ACAD		Drawn	MANDY ONG	10 Oct 2007	Scale: 1 : 1	Reference:
		Approved.	EDWARD TAN	10 Oct 2007		
The copyright of this drawing is reserved by HELLERMANN TYTON. It is issued on condition that it is not reproduced, copied or disclosed to a third party, either wholly or in part, without the consent of HELLERMANN TYTON.	HellermannTyton 545, Yishun Industrial Park A Yishun Avenue 7 Singapore 768741 Tel: (+65) 6852 8585 Fax: (+65) 6756 6798			Title T50RFT6/HR		
				Format		A4
		Sheet 1 of 1

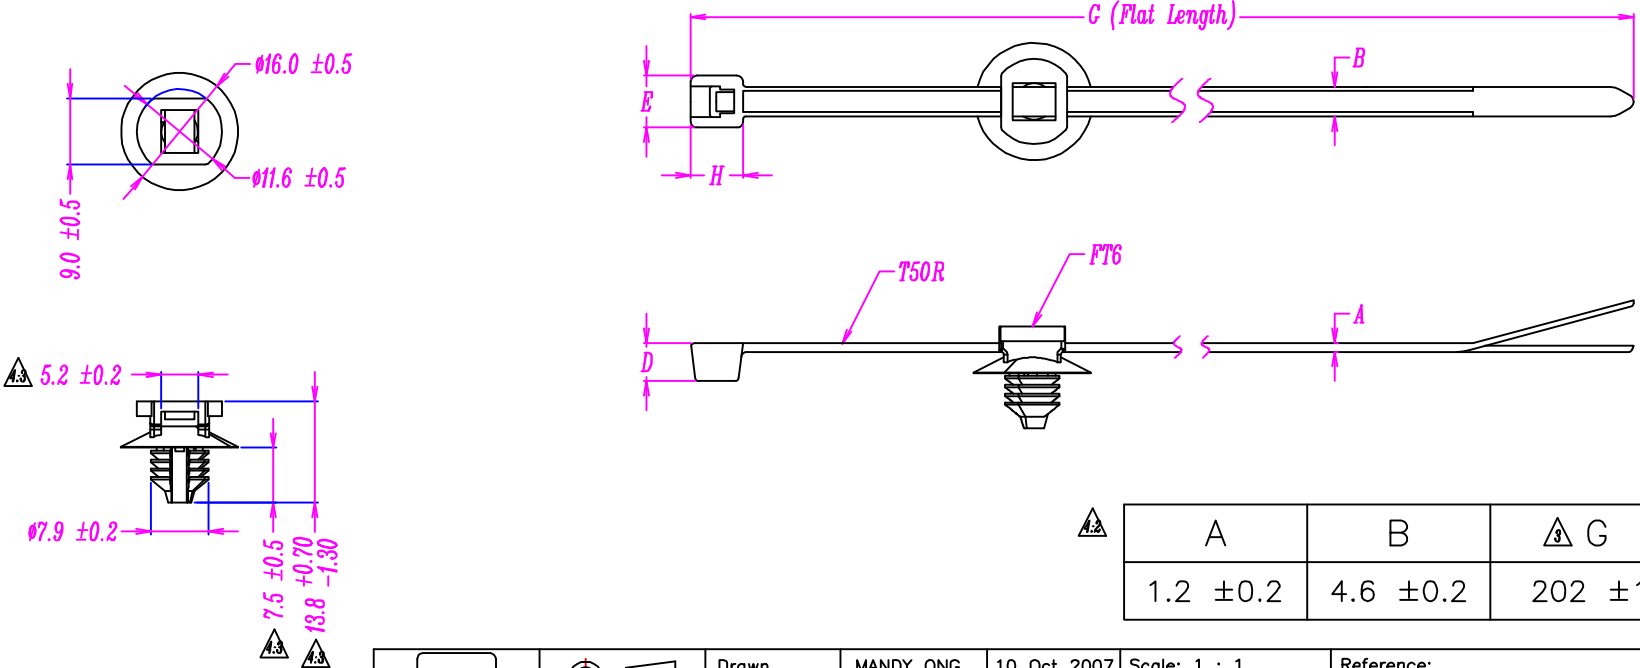
4.1	Added HT Global project Number.	SIMON NG	11-June-19	Edward Tan	11-June-19
	4.2	Remove "D", "E" and "H" from cable tie dimensions chart	SIMON NG	11-June-19	Edward Tan	11-June-19

4.3	(Requested by Amanda Harris to update drawing dimension and tolerance according to drawing no. NT14.1164) 1. Update hole size from $\phi 6.5 \sim \phi 7.0$ to $\phi 6.4 \sim \phi 7.1$ mm 2. Update dimension from 5.0 ± 0.3 to 5.2 ± 0.2 mm 3. Update dimension from 13.5 ± 1.0 to 13.8 ± 0.3 mm 4. Update dimension from 7.2 ± 0.5 to 7.5 ± 0.5 mm	SIMON NG	11-June-19	Edward Tan	11-June-19
